CALIFORNIA COASTAL COMMISSION

Re: Notice of Acceptance—Condition Compliance for CDP #E-07-010 SONGS Mitigation Reef Special Condition #8 – Final Construction Report

The Executive Director has reviewed the “*Final Construction Report for Wheeler North Reef at San Clemente, California*” submitted in compliance with Special Condition #8 of Coastal Development Permit #E-07-010 requiring compliance of the as-built Phase 2 Mitigation Reef to the design specifications laid out in Coastal Development Permit #6-81-330-A (“SONGS” permit), Special Condition C, and in SCE’s “*Final Design Plan, Wheeler North Reef at San Clemente (SONGS Artificial Reef Project, Phase 2 Mitigation Reef)*”, and found that it fulfills the requirements of that condition, as enumerated below.

Phase 1 and 2 Mitigation Reef (WNR), consisting of the experimental modules (dark brown) and primary polygons (green) that combined equal 152.7 acres, approved by the CCC Executive Director as meeting the requirements of SONGS CDP #'s 6-81-330-A and E-07-010.

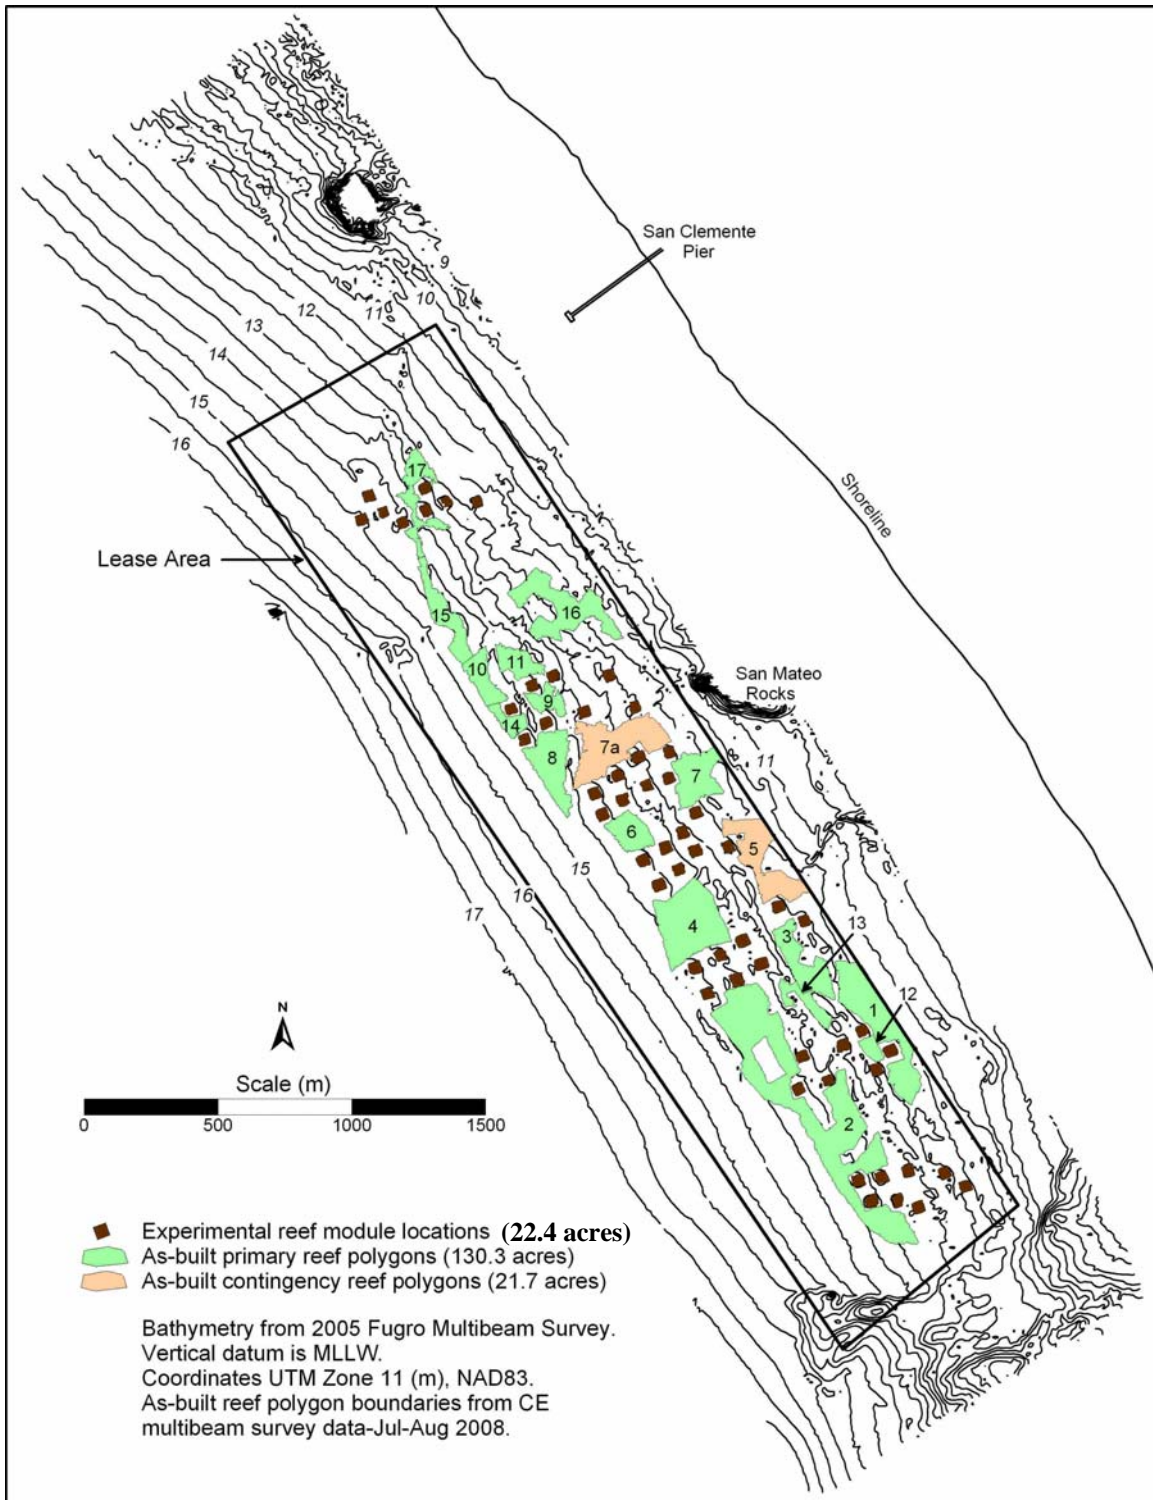
The average percent cover of quarry rock on the 152.02 acre Phase 2 reef (calculated as an average of all polygons weighted by polygon area) is 40.8 percent, which is slightly below the 42 percent minimum requirement specified in SCE's CDPs. To address this deficiency, SCE suggests using a subset of the constructed Phase 2 reef polygons that will result in the minimum 42 percent cover requirement, while still maintaining the 150-acre requirement for the combined Phase 1 and Phase 2 reefs. SCE presents three alternative scenarios in the *Final Construction Report* (Cases 2–4, pg 26). SCE recommends that the Executive Director accept Case 4 in determining which constructed polygons will be counted as meeting the Phase 2 reef requirements. Case 4 would *eliminate* all of primary polygon 5 (9.48 acres) and the north-western section of primary polygon 7 (12.20 acres) (shown as contingency reef polygons 5 and 7a on the attached figure) and *include instead* all constructed contingency polygons (now shown as primary reef polygons on the attached figure) for a total of 130.3 acres of Phase 2 WNR. The weighted average of the 130.3 acres of the Phase 2 reef totals 42.3 percent rock coverage. The Case 4 scenario of 130.3 acres, when combined with the 22.4 acre Phase 1 reef, totals 152.7 acres, and meets the permit requirement for a minimum of 150 acres with an average of at least 42% cover of rock.

The Executive Director agrees that the combination of acreage identified in Case 4 and shown as primary reef polygons on the attached figure fully meets the artificial substrate and acreage requirements for the artificial reef described in Condition C of SONGS CDP #6-81-330-A. Importantly, the acreage identified in Case 4 also meets all the other design specifications of the approved *Final Design Plan*, including that the Phase 2 reef consist of a single-layer reef less than 1 meter in height with no more than 15 percent total overlap, occur in water depth between 11.5 to 15 meters, and be within 10 feet of the designed polygon boundaries. Therefore, the completed Phase 2 WNR as identified in the Case 4 scenario and as shown on the attached figure as primary reef polygons meets all the SONGS permit and SCE *Final Design Plan* specifications listed above and required by CDP #E-07-010, Special Condition #8.

It is important to note that only those areas accepted as meeting the coverage requirement for the Phase 2 reef will be used to evaluate the success of the WNR. The constructed acreage of polygon 5 and the north-western section of polygon 7 (shown as contingency polygons 5 and 7a on the attached figure) do not meet the hard substrate requirement and therefore will not be used by staff to evaluate performance standards that measure the success of the WNR relative to natural reefs in the area. Nevertheless, the Commission contract staff will monitor these contingency polygons concurrently with the monitoring program for the accepted Phase 2 reef so that sufficient data will be available to the Executive Director to consider these contingency polygons for future remediation if needed to fulfill one or more of the permit performance standards. The Commission's 2008-2009 SONGS Mitigation Program budget may require an augmentation to accommodate the additional costs of sampling associated with these contingency polygons.
